EL09-003

ITB09-025

## 2008 – 2009 G37 COUPE; WINDOWS MOVE DOWN / UP WHEN GLOVE BOX IS CLOSED

**APPLIED VEHICLE:** 2008 – 2009 G37 Coupe (CV36) with Vehicle Security System (VSS) accessory impact sensor installed.

Figure 1

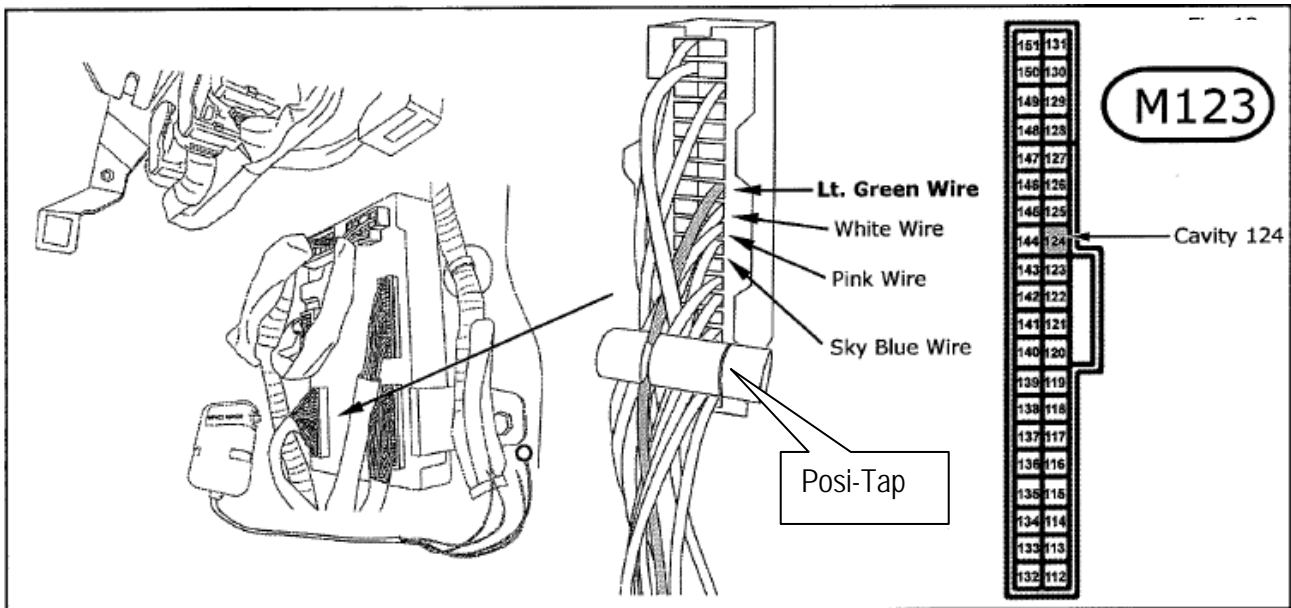
5. Remove / disconnect the impact sensor Brown wire from the Light Green wire in BCM connector 123, cavity 124 (see Figure 1).

Figure 2

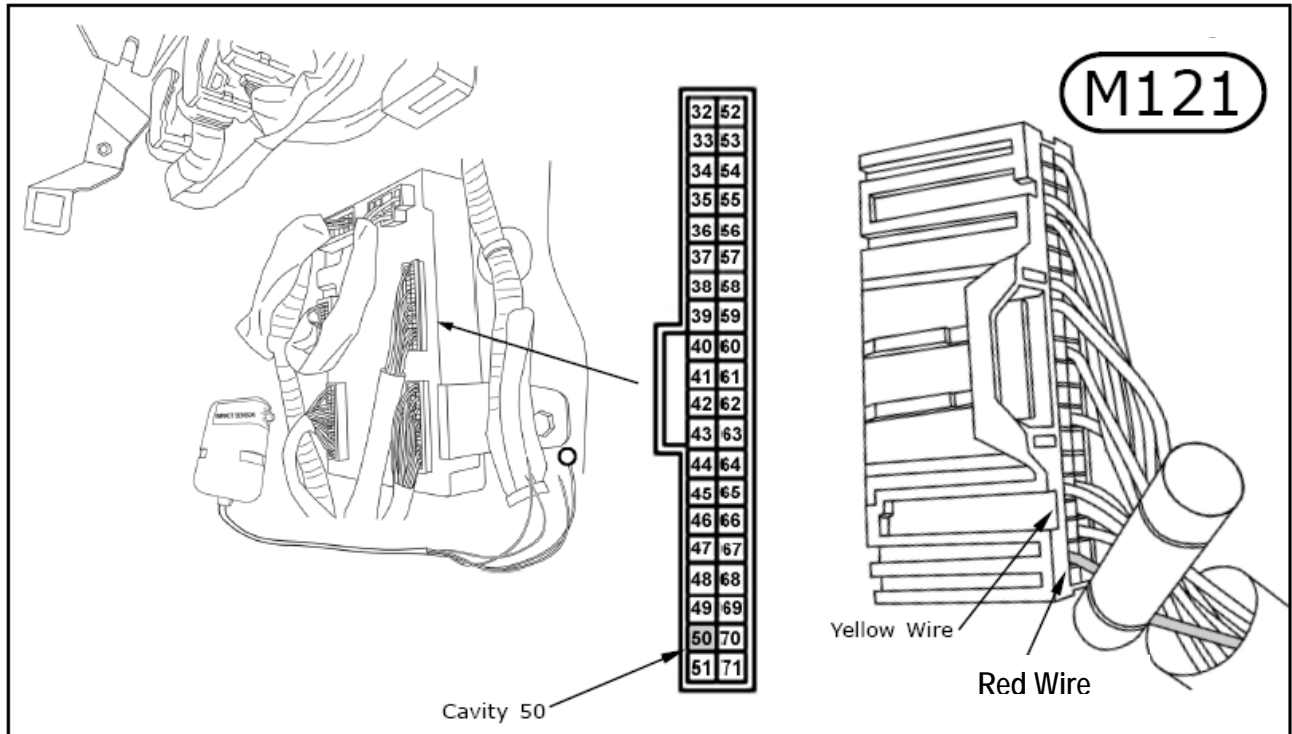
6. Tap / connect the impact sensor Brown wire to the Red wire in BCM connector 121, cavity 50
  - Reuse the Posi-Tap® for wire connection.
  - If needed, refer to Posi-Tap® Use on page 5.
